**PLANNED UNIT DEVELOPMENT &  
SUBDIVISION STAFF REPORT****Date: February 17, 2005**

<b><u>DEVELOPMENT NAME</u></b>	Harkness Subdivision
<b><u>SUBDIVISION NAME</u></b>	Harkness Subdivision
<b><u>LOCATION</u></b>	1601 East I-65 Service Road South (East side of I-65 Service Road South, 950'± North of I-65 Commerce Drive)
<b><u>CITY COUNCIL DISTRICT</u></b>	District 5
<b><u>PRESENT ZONING</u></b>	B-3, Community Business
<b><u>AREA OF PROPERTY</u></b>	2 lots/ 4± acres
<b><u>CONTEMPLATED USE</u></b>	Multiple buildings on a single-building site with shared parking and access between multiple sites.
<b><u>TIME SCHEDULE FOR DEVELOPMENT</u></b>	Immediate
<b><u>ENGINEERING COMMENTS</u></b>	Must comply with all stormwater and flood control ordinances. Any work performed in the right of way will require a right of way permit.
<b><u>TRAFFIC ENGINEERING COMMENTS</u></b>	Driveway number, sizes, location and design to be approved by Traffic Engineering and conform to AASHTO standards.
<b><u>URBAN FORESTRY COMMENTS</u></b>	Property to be developed in compliance with state and local laws that pertain to tree preservation and protection on both city and private properties (State Act 61-929 and City

# SITE PLAN

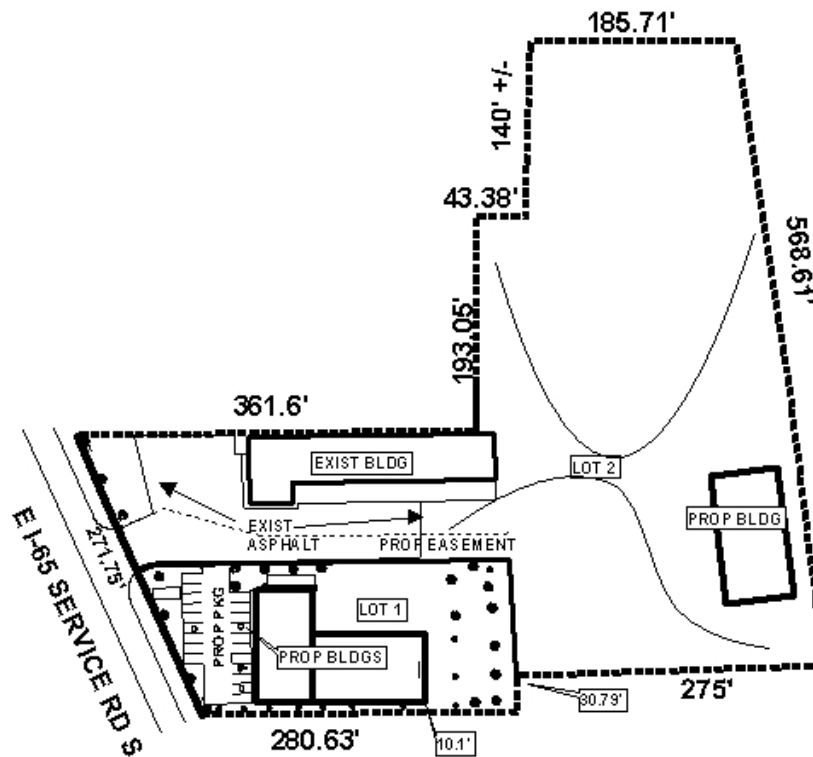
The site is currently developed with a party supply and equipment rental company. The applicant proposes to construct a new building with a showroom and warehouse on the proposed Lot 1, and a new warehouse on the eastern end of Lot 2. The development of Lot 1 will require full compliance with the landscaping and tree planting requirements of the Ordinance, as well as the provision of adequate paved parking. Additionally, as Lot 1 will share access with Lot 2, the provision of frontage trees along Lot 2 should be required.

The eastern portion of Lot 2 is currently developed with gravel, and a new warehouse is proposed. It should be noted that any expansion of the heavy equipment rental operation would require the submission of a Planning Approval application. Additionally, in order to ensure adequate access, parking, circulation and the provision proper buffering, etc., the submission and approval of an Administrative PUD application will be required prior to issuance of a permit for the warehouse on Lot 2.

In regard to the proposed subdivision, the site fronts Interstate 65, a major street as illustrated on the Major Street Plan, and has an existing right-of-way in compliance with the Plan. However, as a means of access management, the site should be limited to one curb cut, with the location and design to be approved by Traffic Engineering. Additionally, Lot 2 would exceed the maximum width to depth ratio as recommended by the Subdivision Regulations; therefore, a waiver of Section V.D.3. would be required. The site is extremely deep, thus the waiver may be considered appropriate.

**RECOMMENDATION**      **Planned Unit Development**      Based upon the preceding, this application is recommended for approval subject to the following conditions: 1) full compliance with the landscaping and tree planting requirements of the Ordinance for Lot 1, as well as the provision of frontage trees for Lot 2; 2) provision of adequate paved parking for the existing building, and new showroom and warehouse; 3) the submission and approval of a Planning Approval application if the heavy equipment rental operation is expanded; 4) the submission and approval an Administrative PUD application prior to the issuance of a permit for the warehouse on the eastern portion of Lot 2; and 5) full compliance with all municipal codes and ordinances.

**Subdivision**      The plat meets the minimum requirements of the Subdivision Regulations and is recommended for Tentative Approval subject to the following condition: 1) placement of a note on the final plat stating that the site is limited to one curb cut, with the location and design to be approved by Traffic Engineering.
